Site Accessibility Evaluation

Americans with Disabilities Act Title II (Public Services: State and Local Government)

**270 S Tejon St
Downtown, CO 80903**

Accessibility Evaluation

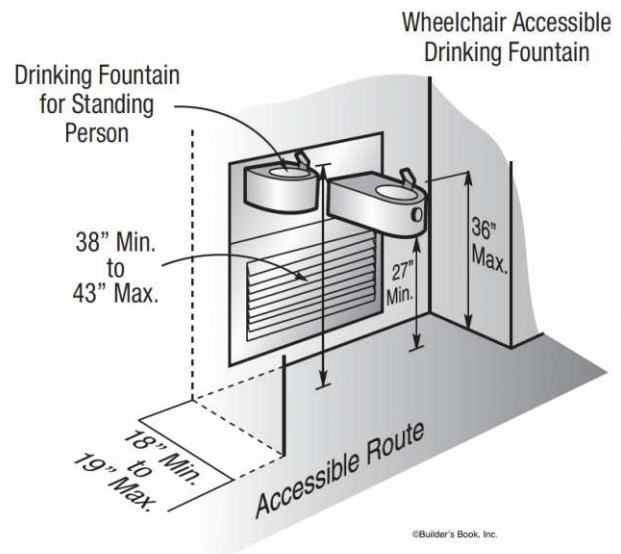
Provide a cup holder at this fountain if set of hi-lo drinking fountains cannot be provided. However, the hi-lo fountain is preferred. A. Wall-mounted objects with leading edges between 27 inches and 80 inches from the floor must not project more than 4 inches into the circulation path. B. Spout outlets shall be 36 inches maximum above the finish floor or ground. C. The spout shall be located 15 inches minimum from the vertical support and 5 inches maximum from the front edge of the unit, including bumpers.

Corrective Action: Work order # 331920 submitted for correction. Installed cup holder dispensers on 8 Sep, 2015 (Temporary measure).

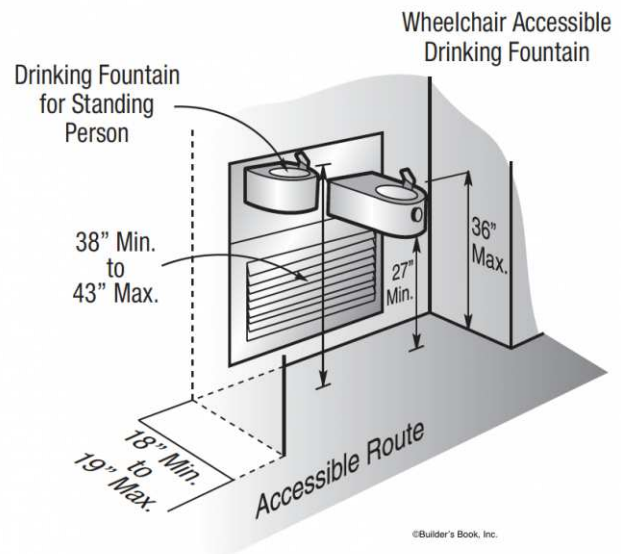
Provide a cup holder at this fountain if set of hi-lo drinking fountains cannot be provided. However, the hi-lo fountain is preferred. A. Wall-mounted objects with leading edges between 27 inches and 80 inches from the floor must not project more than 4 inches into the circulation path. B. Spout outlets shall be 36 inches maximum above the finish floor or ground. C. The spout shall be located 15 inches minimum from the vertical support and 5 inches maximum from the front edge of the unit, including bumpers.

Corrective Action: Work order # 331920 submitted for correction. Installed cup holder dispensers on 8 Sep 2015 (Temporary measure).

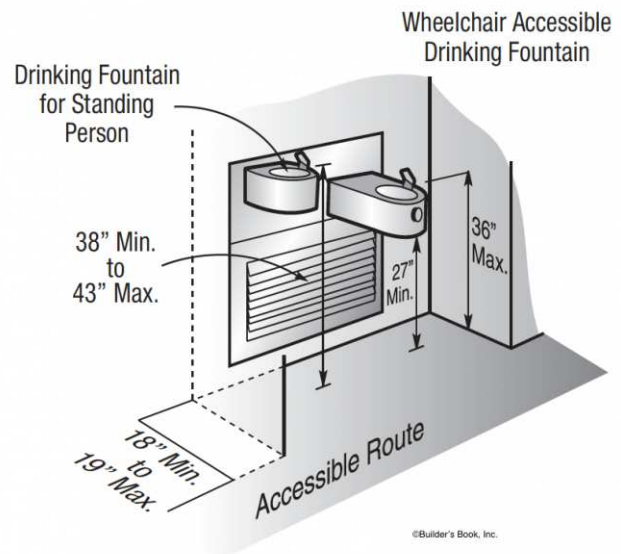
Provide a cup holder at this fountain if set of hi-lo drinking fountains cannot be provided. However, the hi-lo fountain is preferred. A. Wall-mounted objects with leading edges between 27 inches and 80 inches from the floor must not project more than 4 inches into the circulation path. B. Spout outlets shall be 36 inches maximum above the finish floor or ground. C. The spout shall be located 15 inches minimum from the vertical support and 5 inches maximum from the front edge of the unit, including bumpers.

Corrective Action: Work order # 331920 submitted for correction. Installed cup holder dispensers on 8 Sep 2015 (Temporary measure).

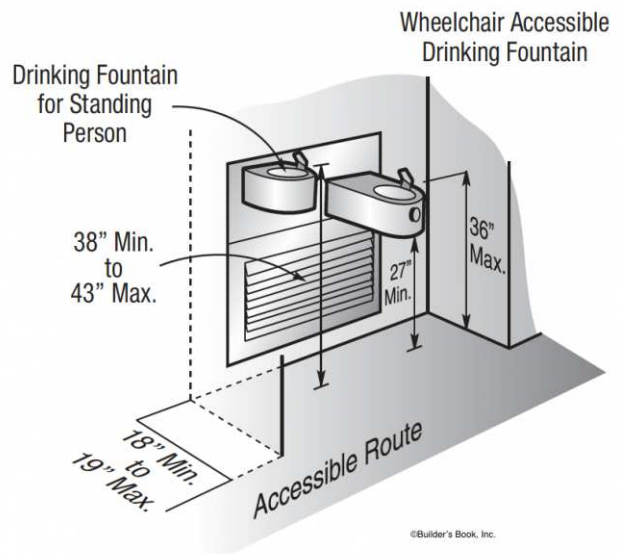
Provide a cup holder at this fountain if set of hi-lo drinking fountains cannot be provided. However, the hi-lo fountain is preferred. A. Wall-mounted objects with leading edges between 27 inches and 80 inches from the floor must not project more than 4 inches into the circulation path. B. Spout outlets shall be 36 inches maximum above the finish floor or ground. C. The spout shall be located 15 inches minimum from the vertical support and 5 inches maximum from the front edge of the unit, including bumpers.

Corrective Action: Work order # 331920 submitted for correction. Installed cup holder dispensers on 8 Sep 2015 (Temporary measure).

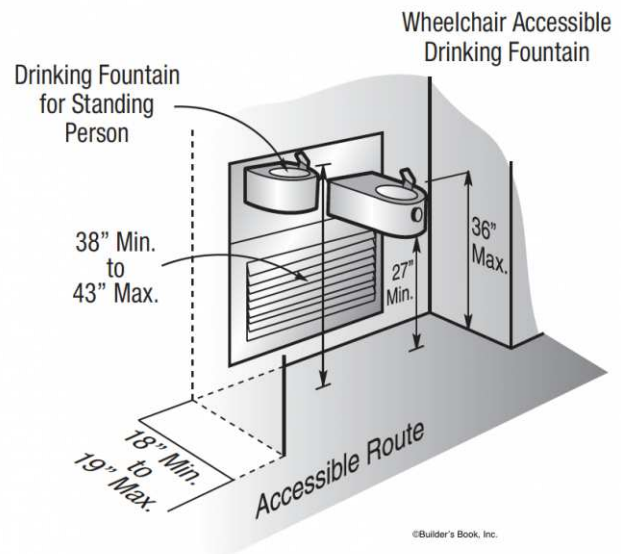
Provide a cup holder at this fountain if set of hi-lo drinking fountains cannot be provided. However, the hi-lo fountain is preferred. A. Wall-mounted objects with leading edges between 27 inches and 80 inches from the floor must not project more than 4 inches into the circulation path. B. Spout outlets shall be 36 inches maximum above the finish floor or ground. C. The spout shall be located 15 inches minimum from the vertical support and 5 inches maximum from the front edge of the unit, including bumpers.

Corrective Action: Work order # 331920 submitted for correction. Installed cup holder dispensers on 8 Sep 2015 (Temporary measure).

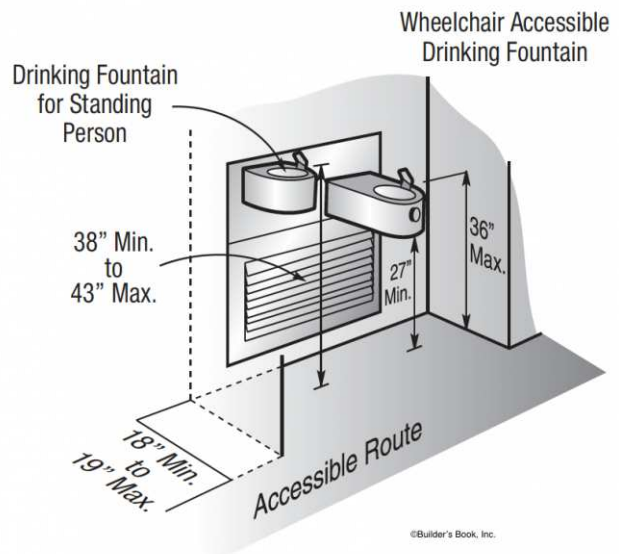
Provide a cup holder at this fountain if set of hi-lo drinking fountains cannot be provided. However, the hi-lo fountain is preferred. A. Wall-mounted objects with leading edges between 27 inches and 80 inches from the floor must not project more than 4 inches into the circulation path. B. Spout outlets shall be 36 inches maximum above the finish floor or ground. C. The spout shall be located 15 inches minimum from the vertical support and 5 inches maximum from the front edge of the unit, including bumpers.

Corrective Action: Work order # 331920 submitted for correction. Installed cup holder dispensers on 8 Sep 2015 (Temporary measure).

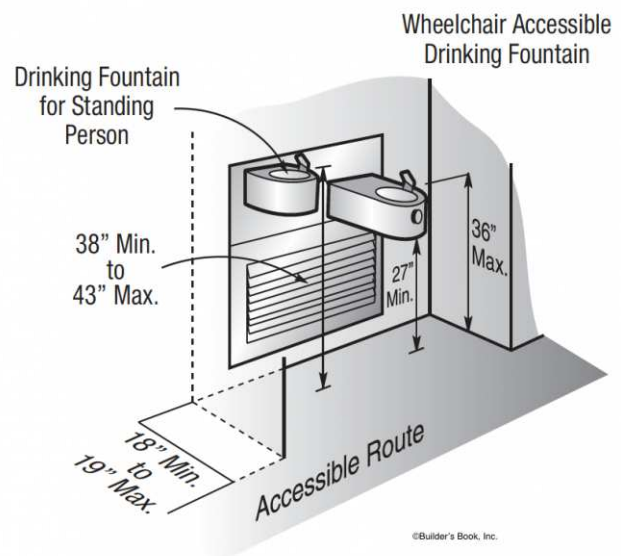
Provide a cup holder at this fountain if set of hi-lo drinking fountains cannot be provided. However, the hi-lo fountain is preferred. A. Wall-mounted objects with leading edges between 27 inches and 80 inches from the floor must not project more than 4 inches into the circulation path. B. Spout outlets shall be 36 inches maximum above the finish floor or ground. C. The spout shall be located 15 inches minimum from the vertical support and 5 inches maximum from the front edge of the unit, including bumpers.

Corrective Action: Work order # 331920 submitted for correction. Installed cup holder dispensers on 8 Sep 2015 (Temporary measure).

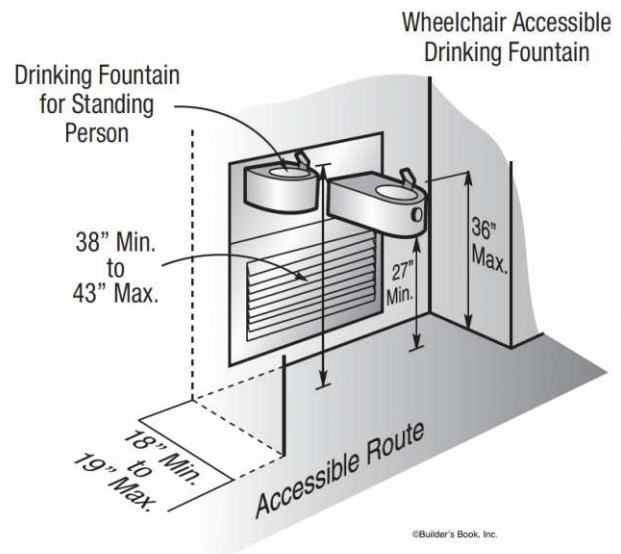
Provide a cup holder at this fountain if set of hi-lo drinking fountains cannot be provided. However, the hi-lo fountain is preferred. A. Wall-mounted objects with leading edges between 27 inches and 80 inches from the floor must not project more than 4 inches into the circulation path. B. Spout outlets shall be 36 inches maximum above the finish floor or ground. C. The spout shall be located 15 inches minimum from the vertical support and 5 inches maximum from the front edge of the unit, including bumpers.

Corrective Action: Work order # 331920 submitted for correction. Installed cup holder dispensers on 8 Sep 2015 (Temporary measure).

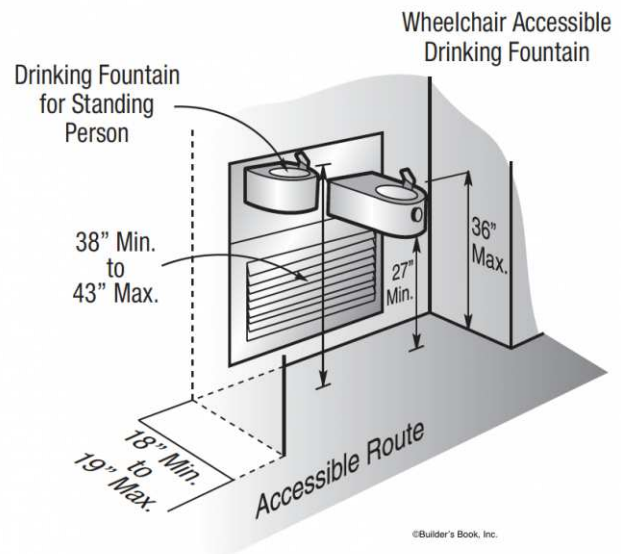
Provide a cup holder at this fountain if set of hi-lo drinking fountains cannot be provided. However, the hi-lo fountain is preferred. A. Wall-mounted objects with leading edges between 27 inches and 80 inches from the floor must not project more than 4 inches into the circulation path. B. Spout outlets shall be 36 inches maximum above the finish floor or ground. C. The spout shall be located 15 inches minimum from the vertical support and 5 inches maximum from the front edge of the unit, including bumpers.

Corrective Action: Work order # 331920 submitted for correction. Installed cup holder dispensers on 8 Sep 2015 (Temporary measure).

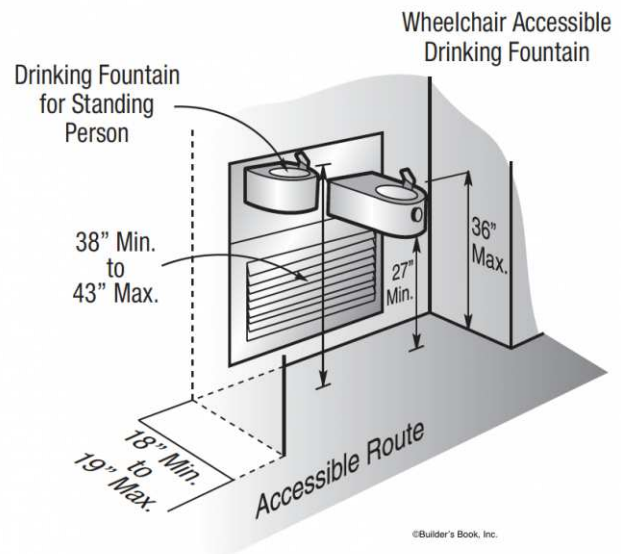
Provide a cup holder at this fountain if set of hi-lo drinking fountains cannot be provided. However, the hi-lo fountain is preferred. A. Wall-mounted objects with leading edges between 27 inches and 80 inches from the floor must not project more than 4 inches into the circulation path. B. Spout outlets shall be 36 inches maximum above the finish floor or ground. C. The spout shall be located 15 inches minimum from the vertical support and 5 inches maximum from the front edge of the unit, including bumpers.

Corrective Action: Work order # 331920 submitted for correction. Installed cup holder dispensers on 8 Sep 2015 (Temporary measure).

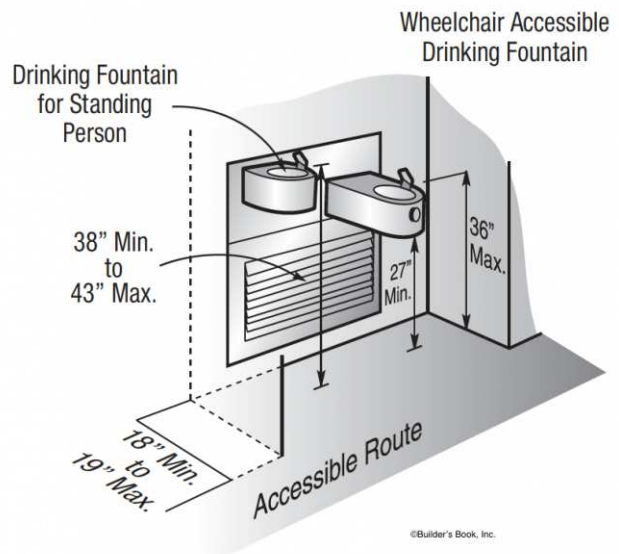
Provide a cup holder at this fountain if set of hi-lo drinking fountains cannot be provided. However, the hi-lo fountain is preferred. A. Wall-mounted objects with leading edges between 27 inches and 80 inches from the floor must not project more than 4 inches into the circulation path. B. Spout outlets shall be 36 inches maximum above the finish floor or ground. C. The spout shall be located 15 inches minimum from the vertical support and 5 inches maximum from the front edge of the unit, including bumpers.

Corrective Action: Work order # 331920 submitted for correction. Installed cup holder dispensers on 8 Sep 2015 (Temporary measure).

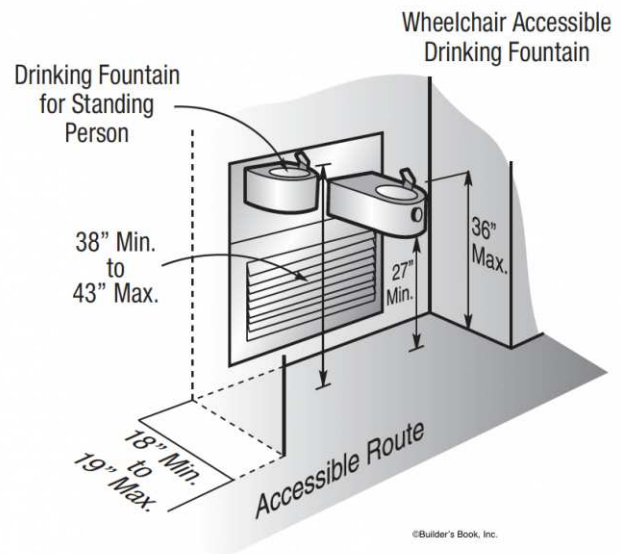
Provide a cup holder at this fountain if set of hi-lo drinking fountains cannot be provided. However, the hi-lo fountain is preferred. A. Wall-mounted objects with leading edges between 27 inches and 80 inches from the floor must not project more than 4 inches into the circulation path. B. Spout outlets shall be 36 inches maximum above the finish floor or ground. C. The spout shall be located 15 inches minimum from the vertical support and 5 inches maximum from the front edge of the unit, including bumpers.

Corrective Action: Work order # 331920 submitted for correction. Installed cup holder dispensers on 8 Sep 2015 (Temporary measure).

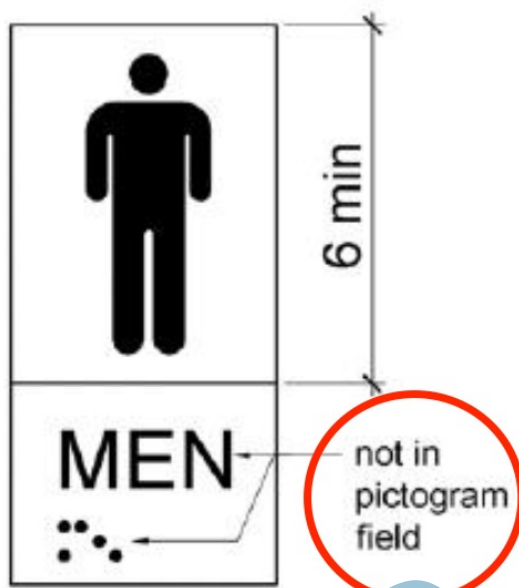
Replace sign with compliant pictogram field of no less than 6 inches in height.
